3.1 Geology, Soils, and Topography

Figure 3.1-2: Slopes Map
 Raleigh and Heiden Properties
 Town of Fallsburg, Sullivan County, New York
 Source: Lanc & Tully Engineering and Surveying, P.C.
 Site Plan: TMA, rev. date 4/11
 Scale: As shown

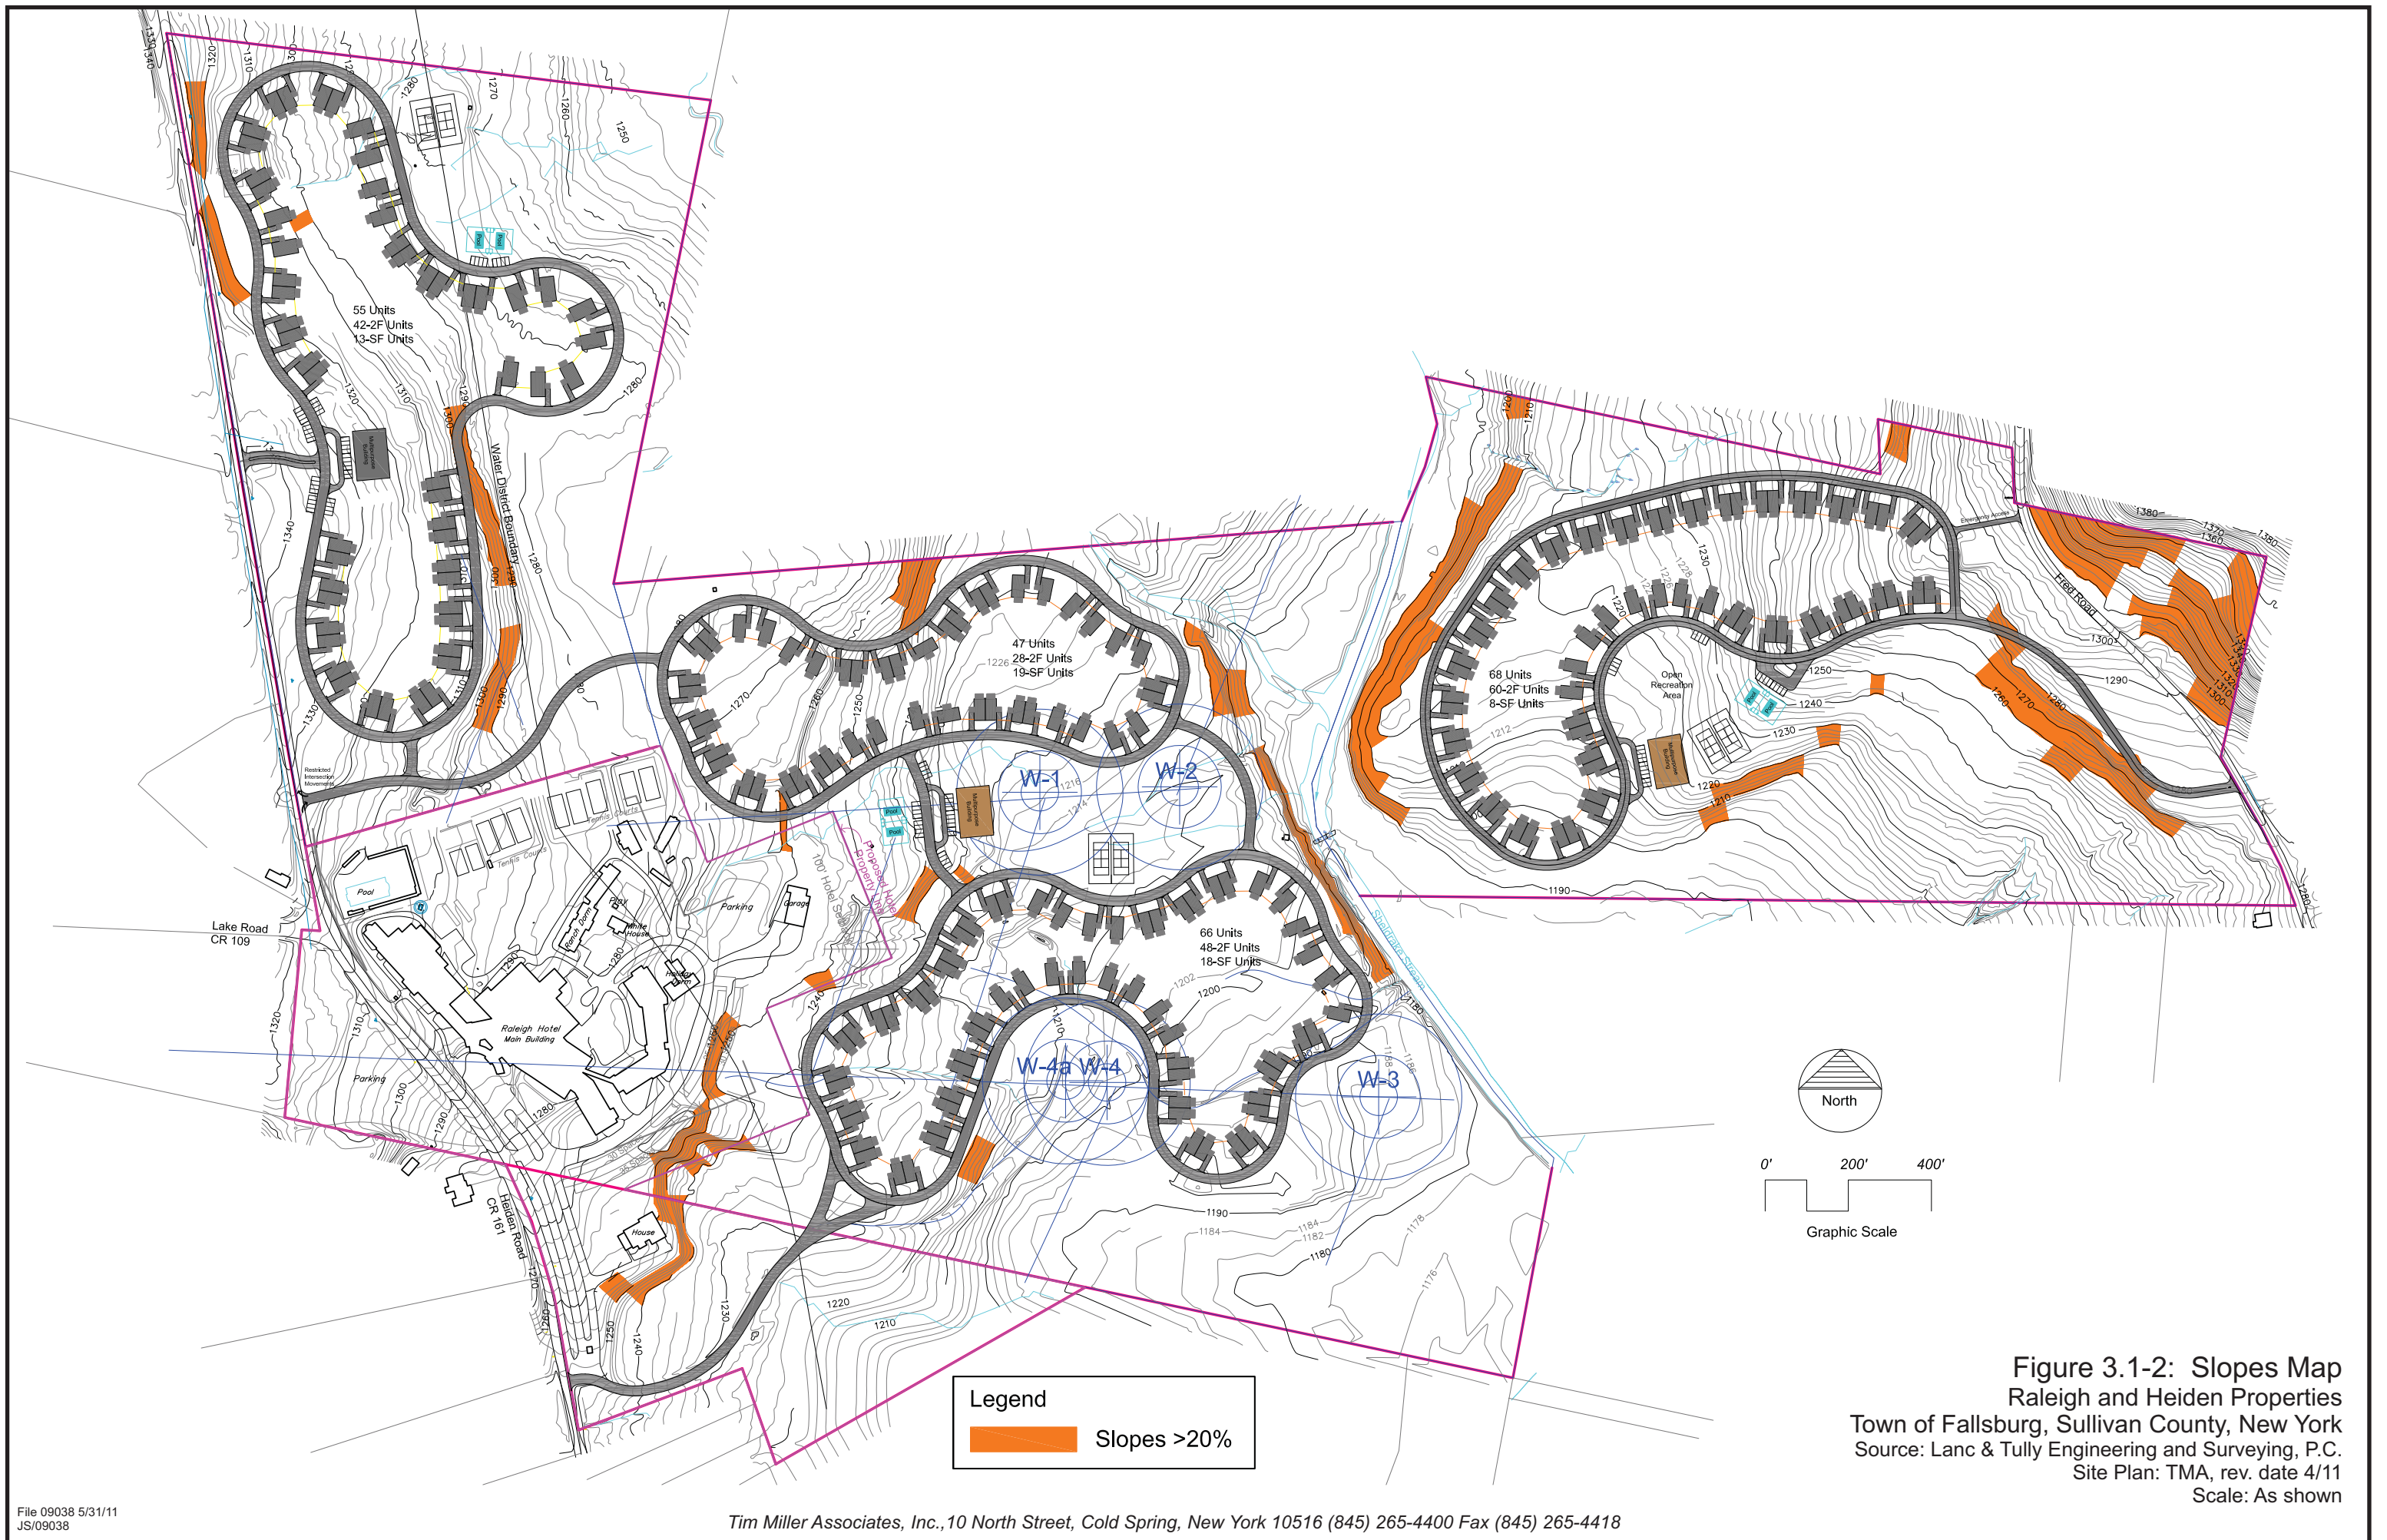
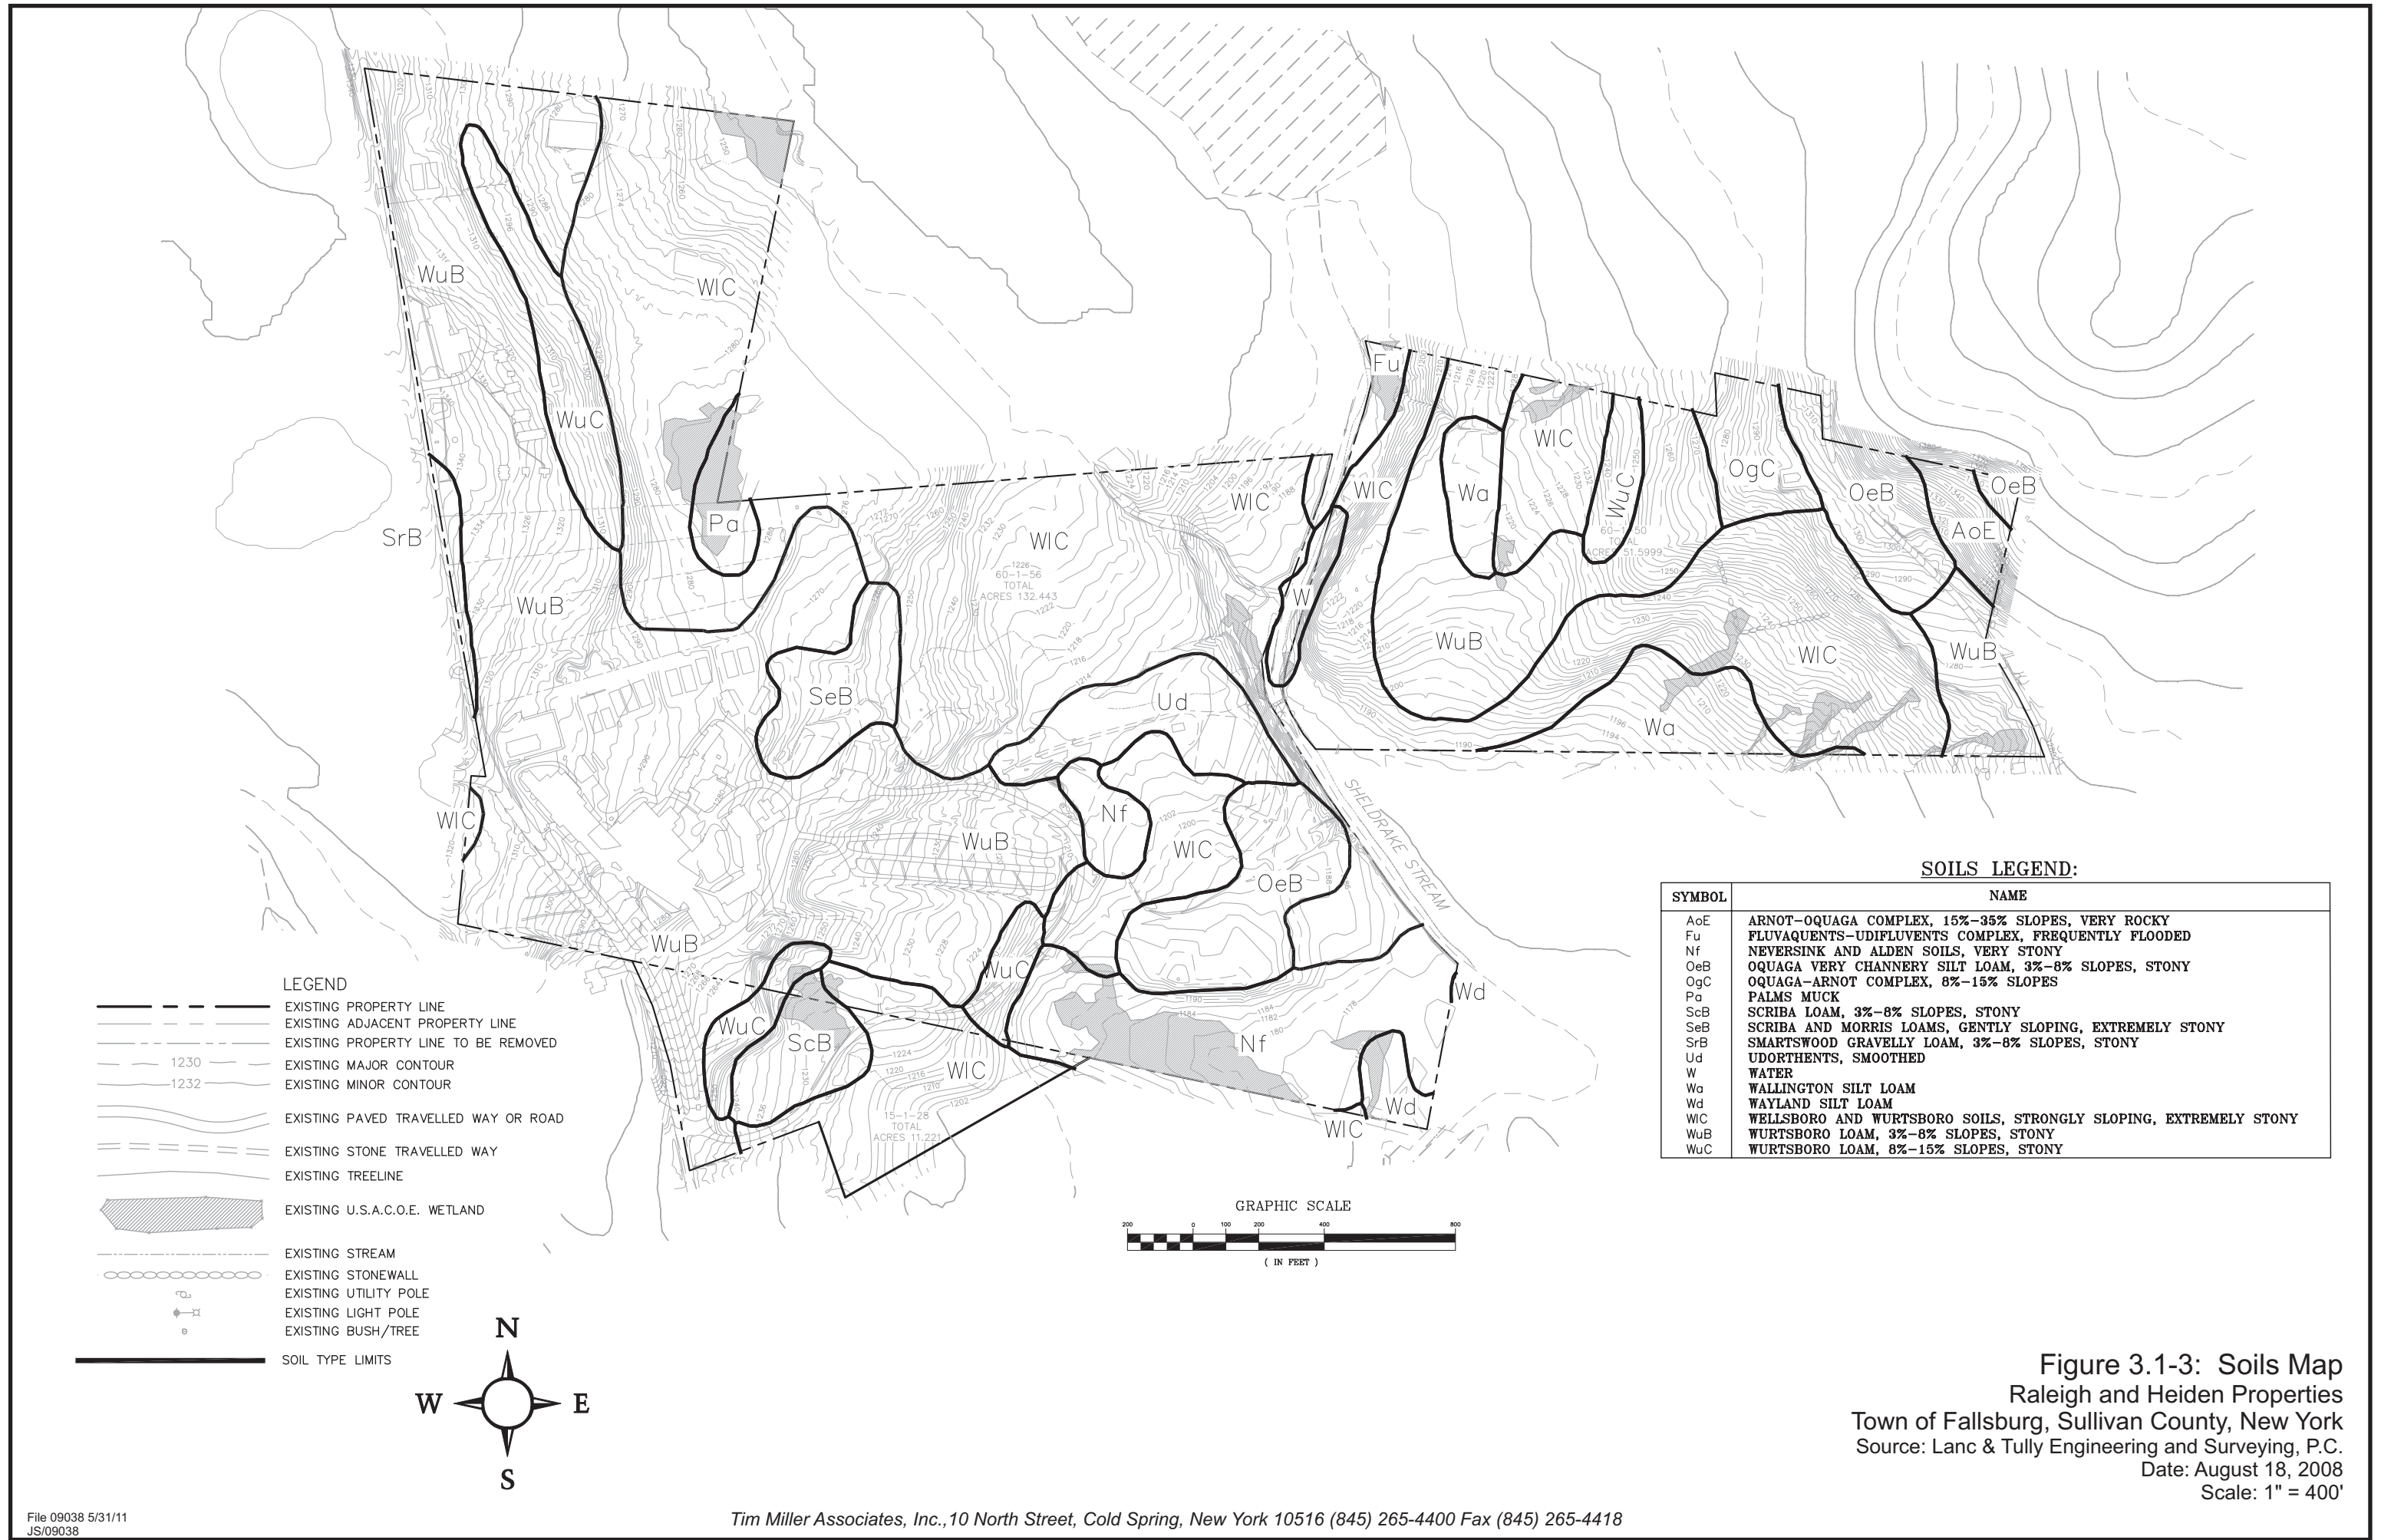
Comment 3.1-3 (Letter to Planning Board, December 16, 2011, Fallsburg Fishing and Boating Club, James Creighton): Although the DEIS proposes disturbance of 4.1% of the total steep slopes area in excess of 20%, the DEIS should include additional information regarding the amount of disturbance proposed on slopes from 15-20% and 10-15%. It should be noted that the applicant's undated long form SEQRA assessment filing for this project attached as DEIS Appendix A shows that 25% of the site consists of 15% or greater steep slopes.

Comment 3.1-4 (Letter to Planning Board, December 16, 2011, Fallsburg Fishing and Boating Club, James Creighton): In particular, the slopes alongside the Sheldrake Stream and the unnamed stream feeding from the Heiden Road wetlands from the northwestern portion of the site toward the Sheldrake Stream are very significant and should remain undisturbed to the largest extent possible. Irreversible damage to water quality to the Sheldrake Stream – a Class B(t) waterbody (a part of the Middle Delaware River Watershed) should be avoided at all costs, and the applicant should supplement the DEIS to describe the measures to be taken to ensure that said slopes will remain undisturbed.

Response 3.1-3: *The project scope requires that steep slopes on the property (steep slopes being defined as greater than 20 percent) be mapped for the site and the steep slope disturbance be calculated. The Town of Fallsburg Code defines steep slopes in residential zones as greater than 20 percent; it is defined as greater than 15 percent in non-residential zones. This has been completed and is included in the October 13, 2011 DEIS.*

Response 3.1-4: *The slopes adjacent to the Sheldrake Stream and the unnamed tributary to it, located within the northwestern portion of the property, will be left undisturbed except for the installation of the water and sewer mains to cross under the Sheldrake Stream to the eastern portion of the project site. Any disturbance to areas adjacent to Sheldrake Stream will be completed in conformance with the erosion control plan and with the requirements of the General Permit.*
